Modification Declaration

Quemlink Wireless Solutions Co., Ltd.

Quemlink Wireless Solutions Co., Ltd. respectfully requests class II permissive change for FCC ID: YQD-GL53MG.(original Grant date: 01/23/2022)

Figure 1. GL53MG

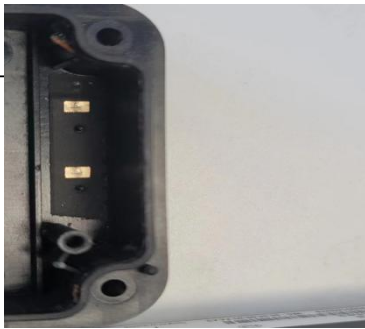
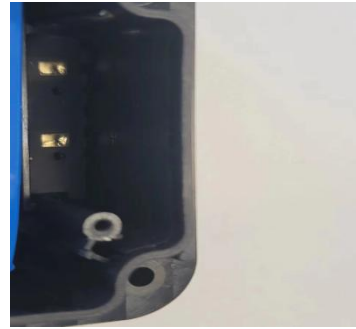
- Add series model GL53MG Plus
- Replaced 4400mAh battery for GL53MG Plus GL53MG uses 2400mAh battery.
- Change the same type antenna for GL53MG Plus.

Figure 2. GL53MG Plus

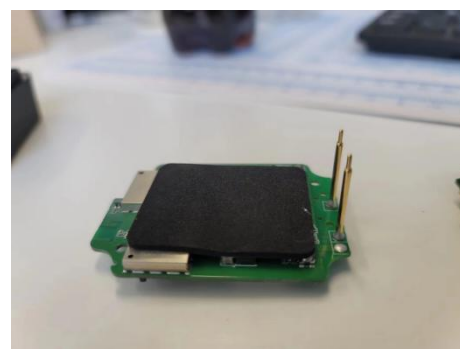
- Compared with GL53MG, GL53MG Plus has thicker backshell, longer antenna thimbles and one less thimble.
